[Docket No. FAA-2019-0469; Product Identifier 2019-CE-028-AD; Amendment 39-19664; AD 2019-12-09]

Airworthiness Directives; Rockwell Collins, Inc. Flight Display System Application

ACTION: Final rule; request for comments.

Figure 1 to paragraph (g)(3) of this AD; placard location on bezel

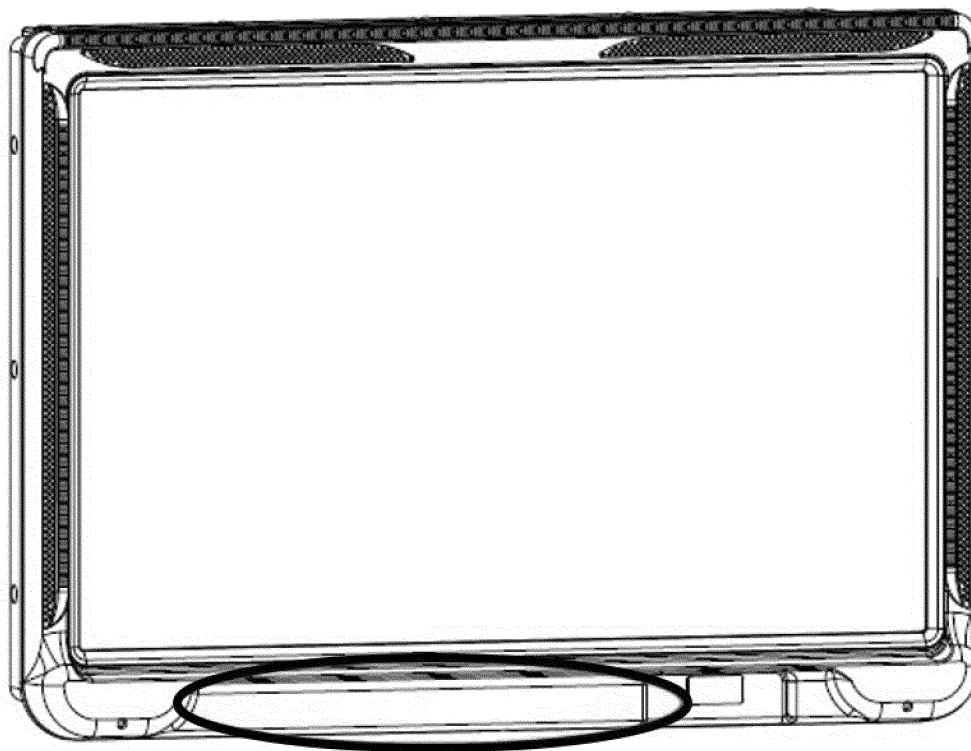
(2) Fabricate a placard for each aircraft primary flight display, using at least 1/8 inch letters, with the following text: TCAS Flight Ops—TA Only mode (TA/RA mode prohibited).

(3) Install the placard on the bottom of each aircraft primary flight display bezel in the area depicted in figure 1 to paragraph (g)(3) of this AD.
